PLANNING DIVISION STAFF REPORT

Project Address: 5533 University Avenue (District 19 – Ald. Clear)
Application Type: Demolition and Conditional Use
Legistar File ID #: [49138](#)
Prepared By: Chris Wells, Planning Division
Report Includes Comments from other City Agencies, as noted
Reviewed By: Kevin Firchow, AICP, Principal Planner

Requested Action: The applicant is making five requests with this proposal – 1) approval of the demolition of a grocery store; 2) approval of a conditional use for the construction of a building with over eight (8) dwelling units; 3) approval of a conditional use for a building exceeding ten thousand (10,000) square feet floor area and containing two or more uses; 4) approval of a conditional use for a building exceeding three stories in height; and 5) approval of a conditional use for a building exceeding the allowed rear yard height transition to a residential district – in order to construct a four-story, mixed-use building with 5,600 square feet of commercial space and 56 apartments at 5533 University Avenue; Urban Design Dist. 6; 19th Ald. Dist.

Image 1: Section Looking Eastward

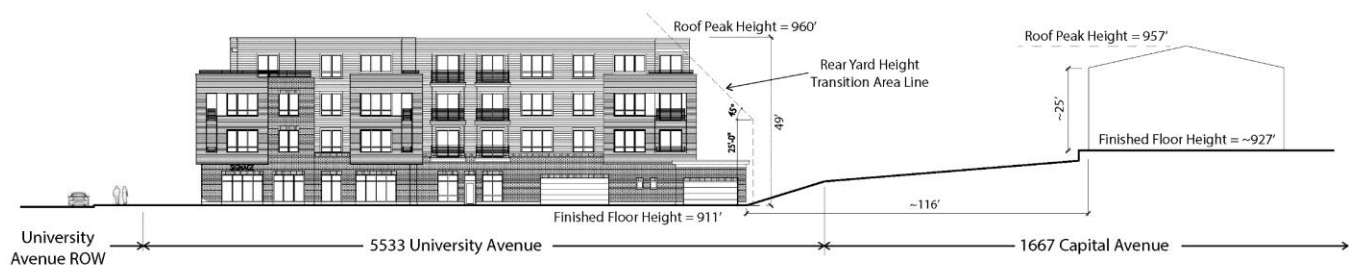
Looking at Image 1 below, one can see the upper right corner of the building (i.e. the southeasterly corner of the building’s fourth floor) extending into the transition area (which is indicated by the angled dashed line). While such a restriction on height transitions is most applicable, and valuable, in infill situations when, for example, a multi-story building is proposed on a block of small and/or narrow lots, for the 5533 University Avenue case, Planning Staff anticipate that that this specific encroachment will not result in significantly different impacts than what would be allowed without the requested conditional use. This is due to the fact that the structures are not only approximately 116 feet away but due to the amount of grade change between properties, the level of the ground floor of the neighboring two-story residential building is roughly 16 feet above that of the subject building.
